Appendix A Submissions

Re: Multi-storey Carpark at Westmead Hospital (SSD 7262) – Review of Environmental Impact Statement.

SSD 7262 – WESTMEAD HOSPITAL – MULTI-STOREY CARPARK EIS

**DEMOLITION AND CONSTRUCTION OF A MULTI-STORY CARPARK AT WESTMEAD
HOSPITAL PRECINCT, CORNER OF DARCY ROAD & INSTITUTE ROAD IN WESTMEAD**

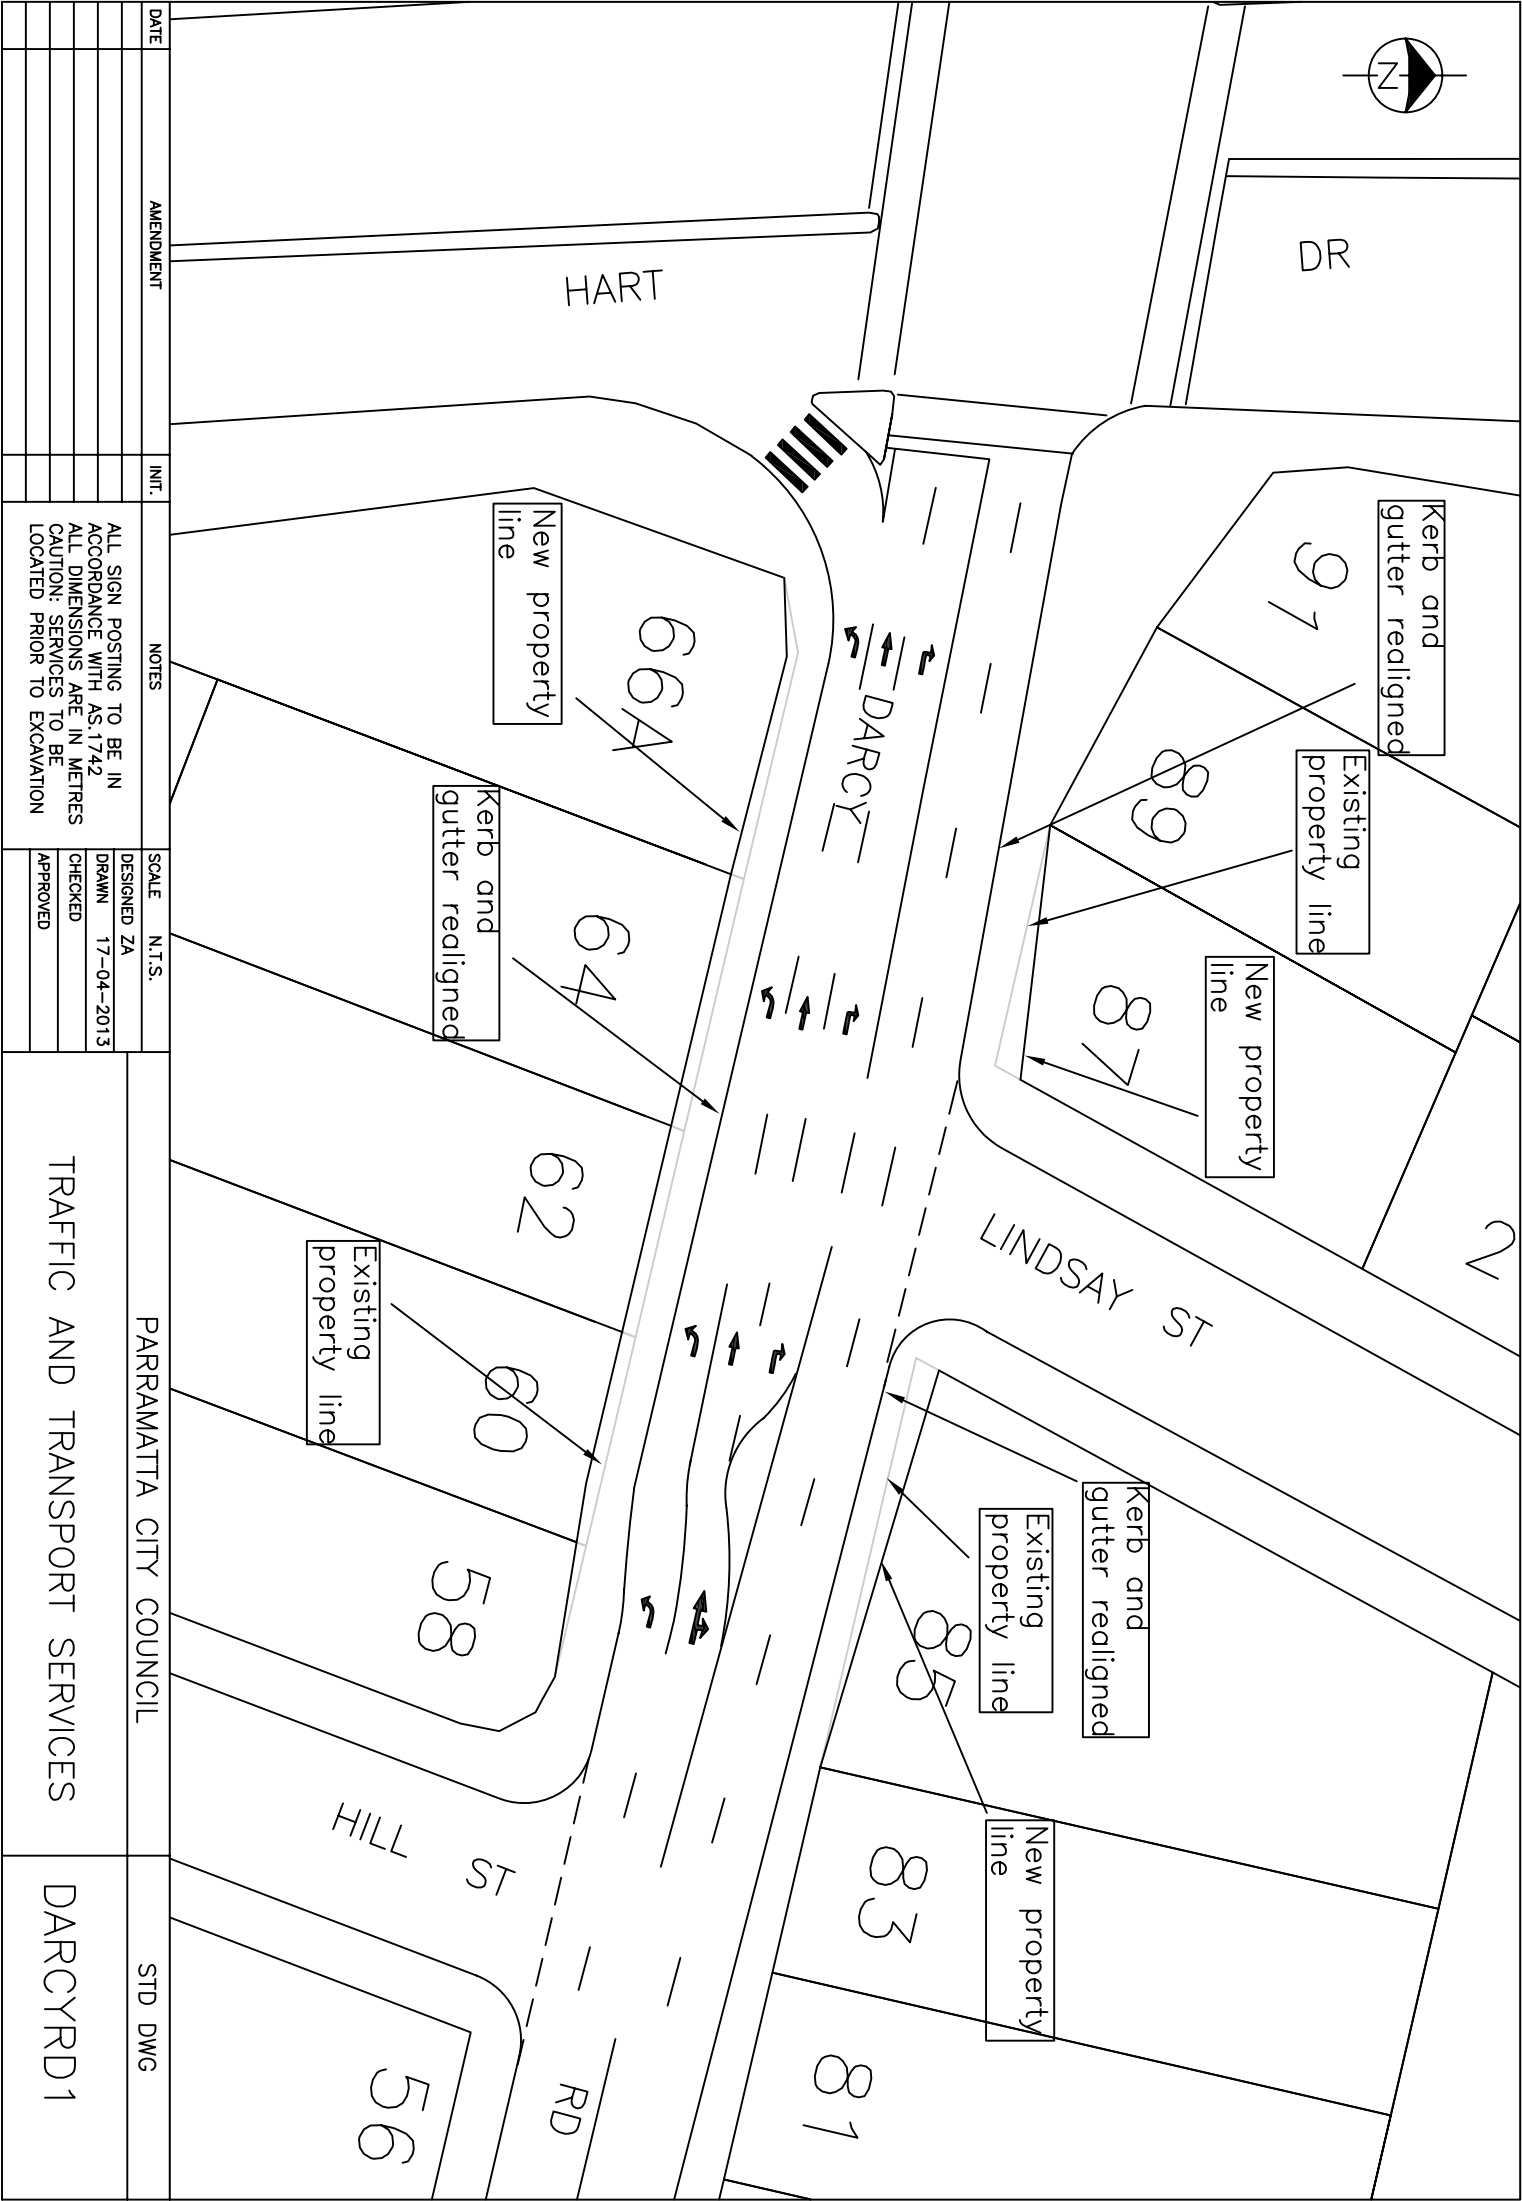
Council has identified works that can undertaken at these intersections. It is considered that the project that is most directly related to the Medical Precinct, and would give the greatest benefit, is the widening of Darcy Road to the east of Cumberland Highway, to provide a westbound left turn lane. A plan of this proposal is attached. It is

recommended that the design, land acquisition and construction for this project be undertaken as part of the increase in parking that is being undertaken by Health NSW.
